**VILLAGE OF POMONA
BOARD OF PLANING MEETING**

Project Name: 85 Camp Hill Road

To: Village of Pomona Planning Board

TO: Village of Pomona Planning Board
FROM: Martin K. Spence, PE Village Engineer
DATE: March 11, 2026
RE: **85 Camp Hill Road Tax Map Reference 32.08-1-51**

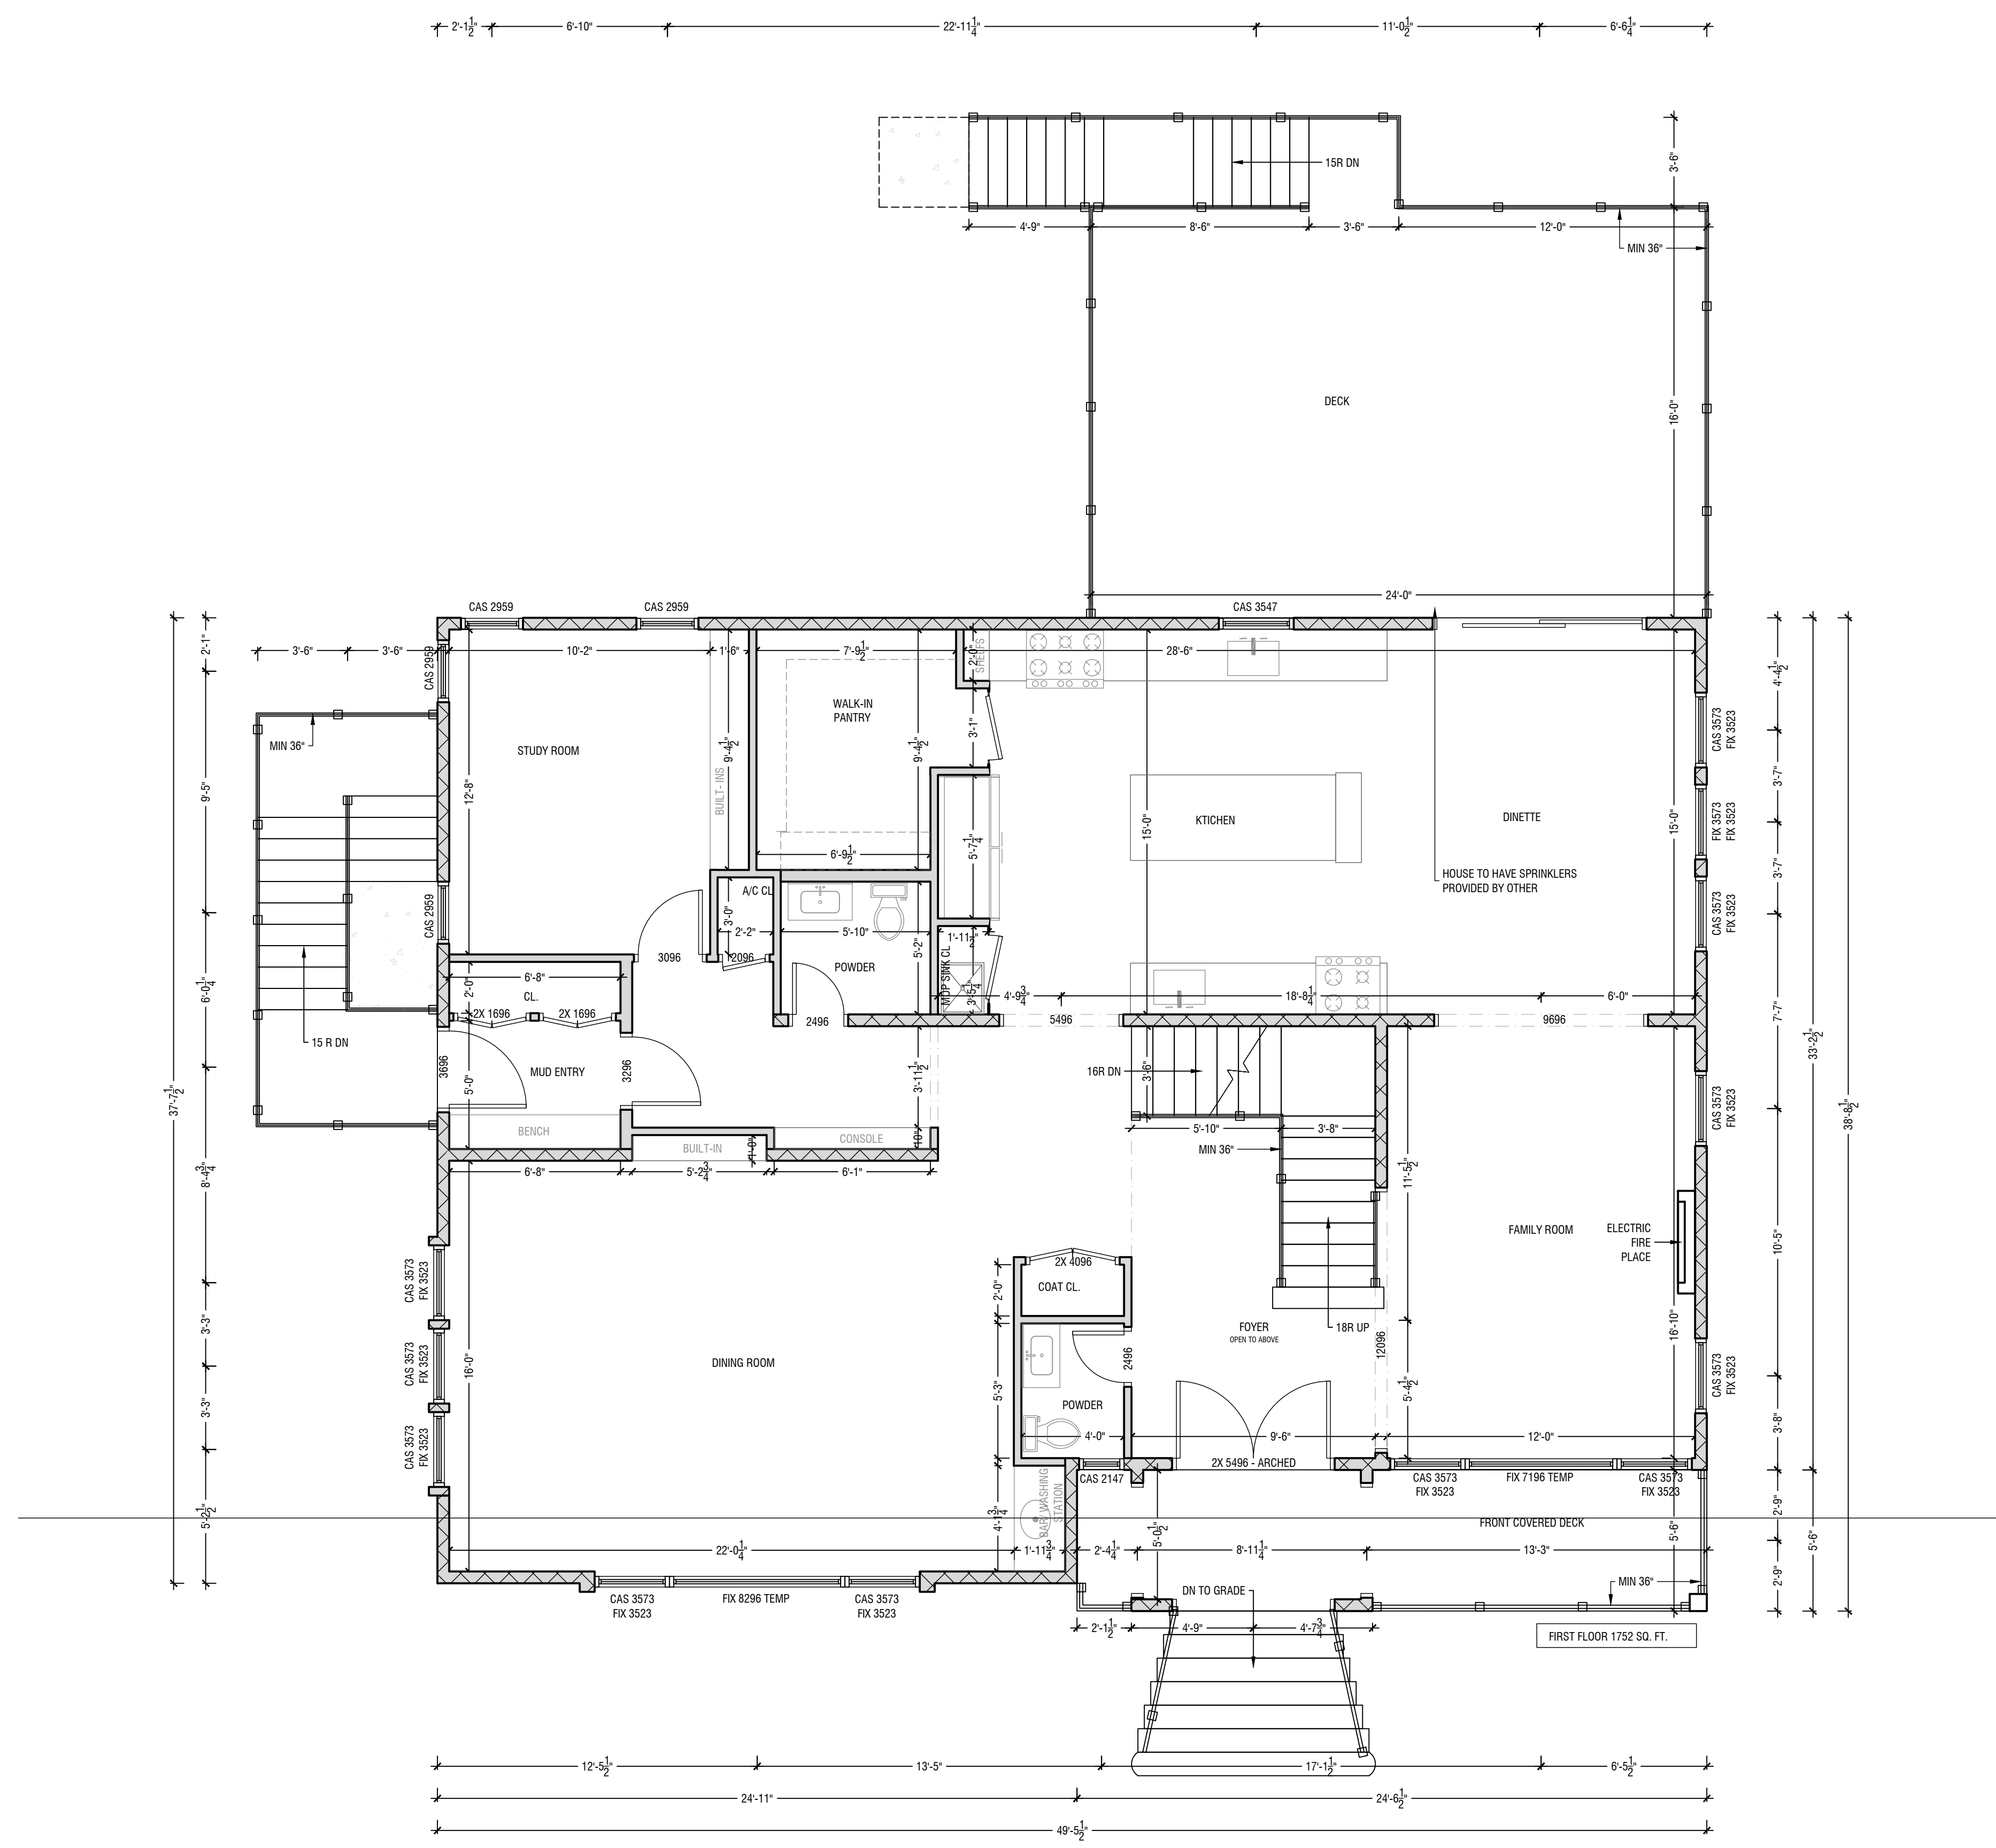
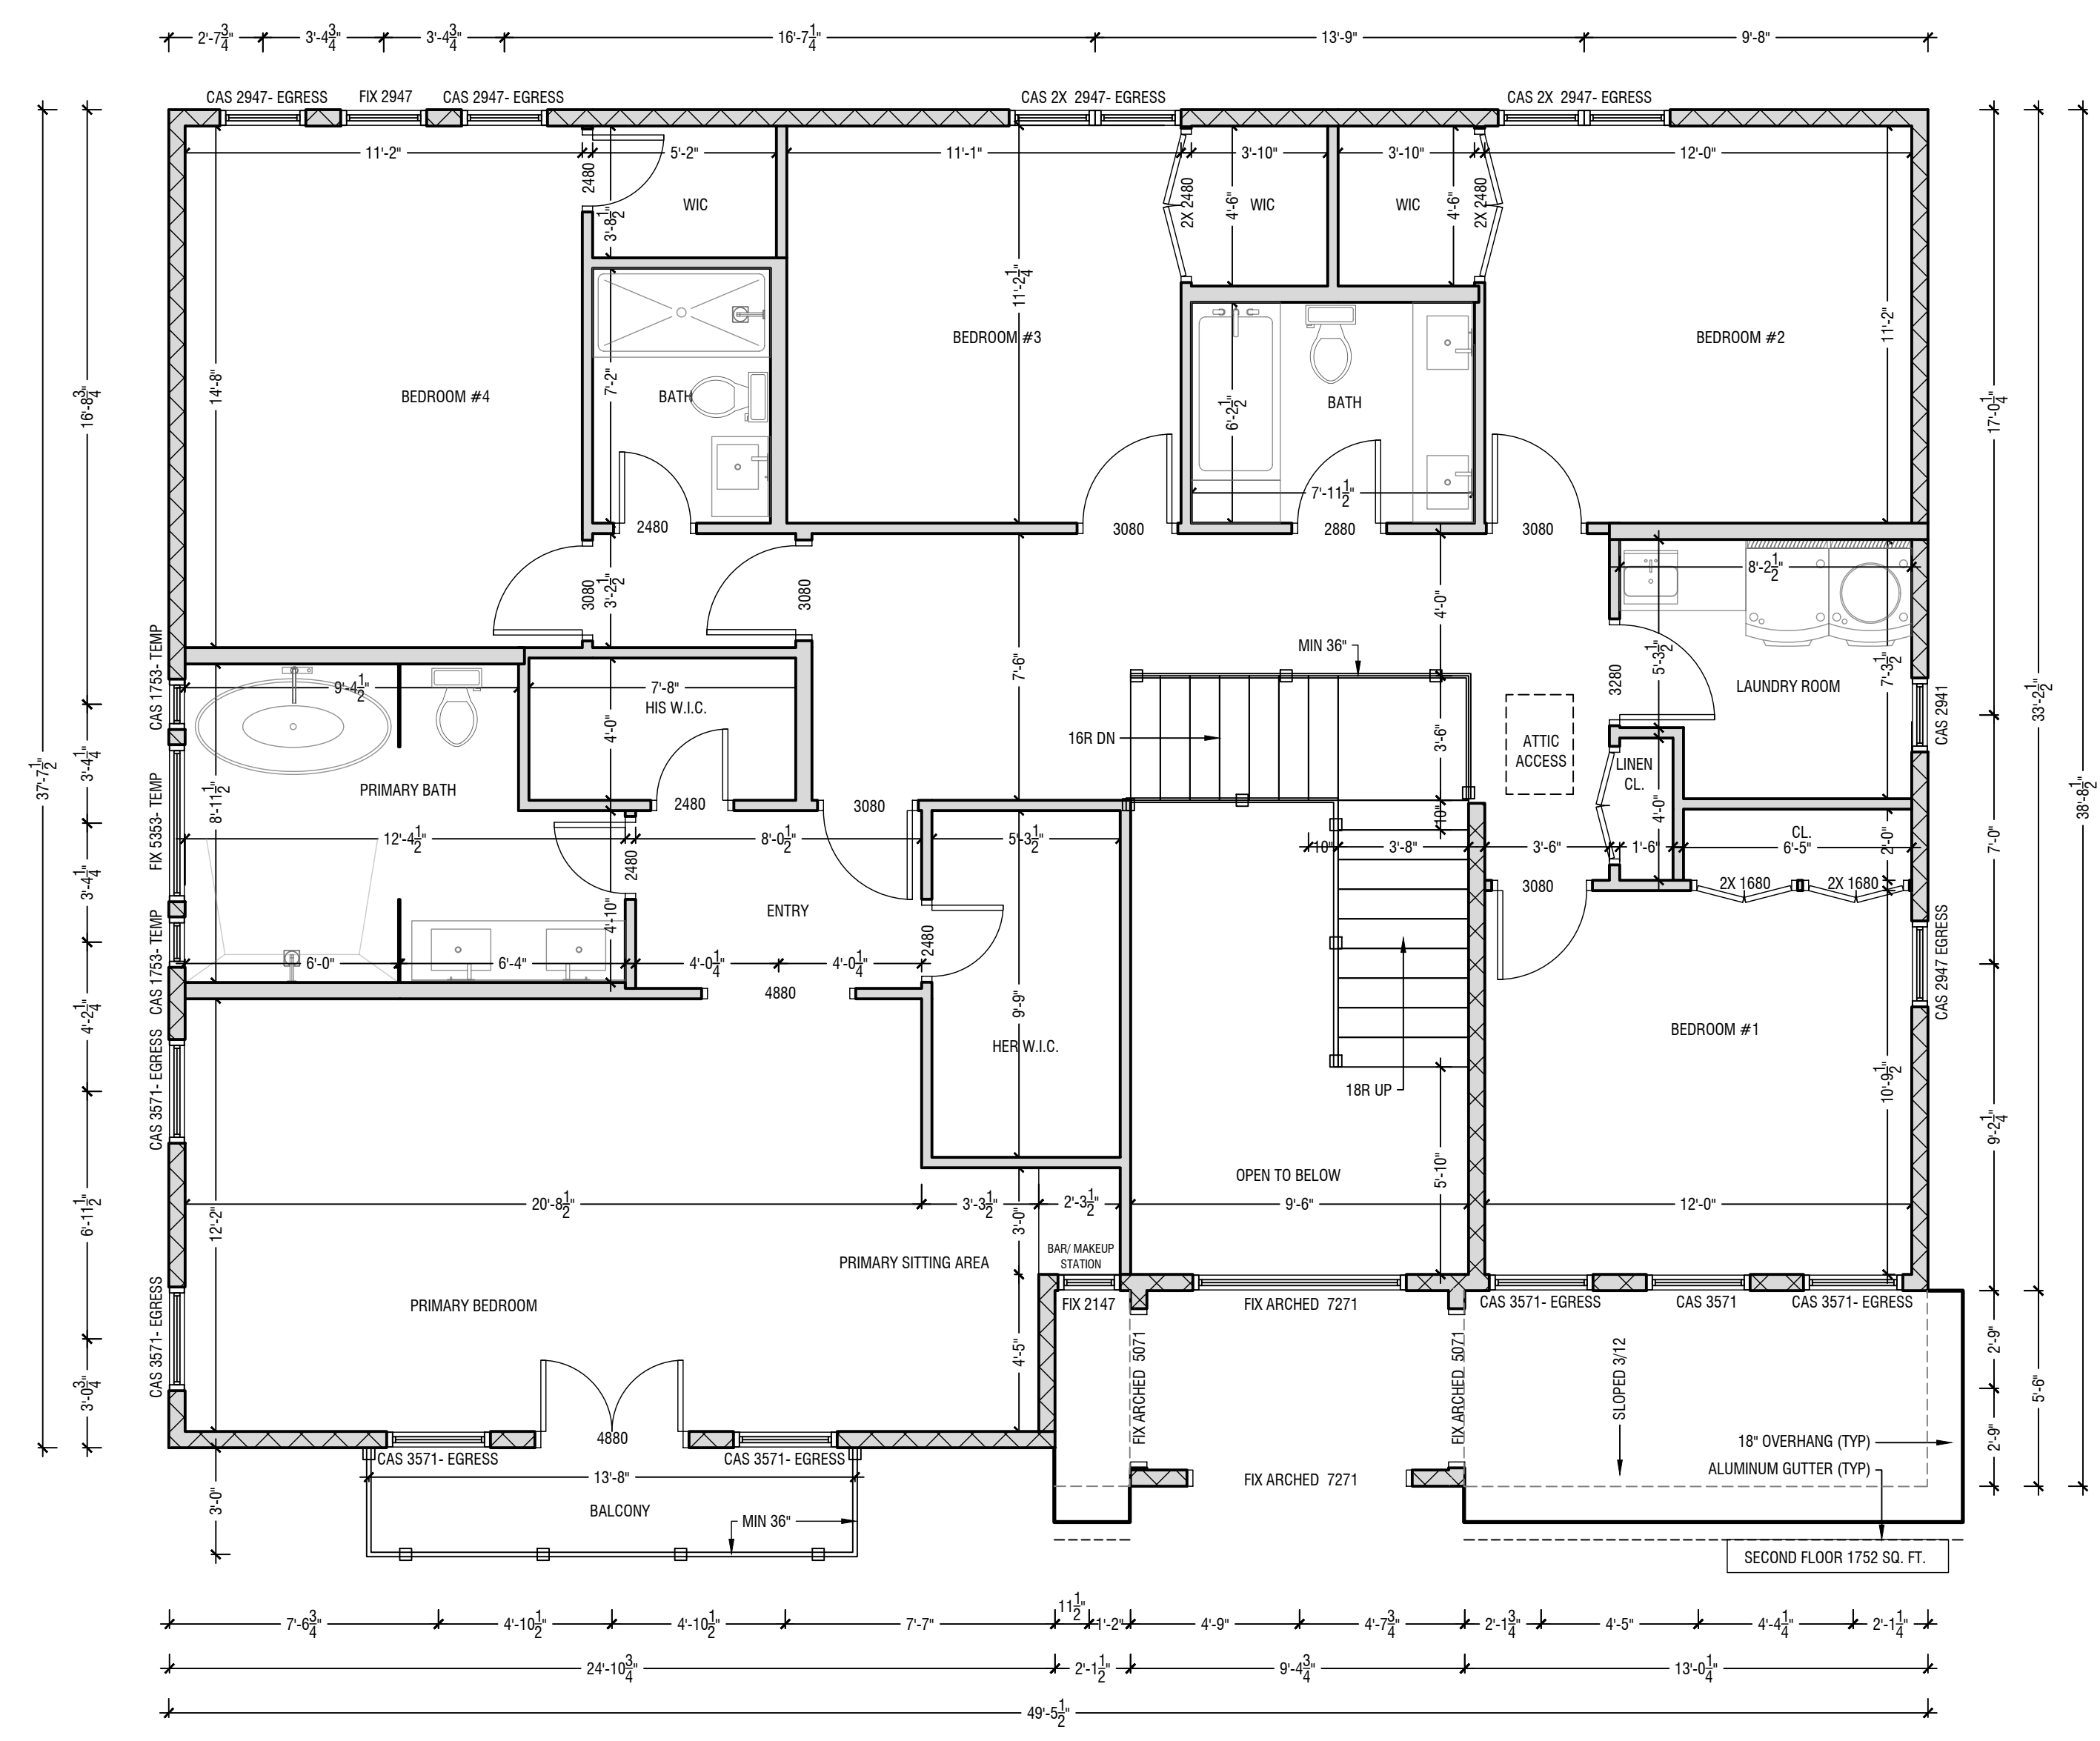
1. Please indicate the square footage for each floor of the structure proposed on sheets 3, 4 & 5 of the Architectural Plans. 10/2025 Not Addressed; **2/2026 Not Addressed**
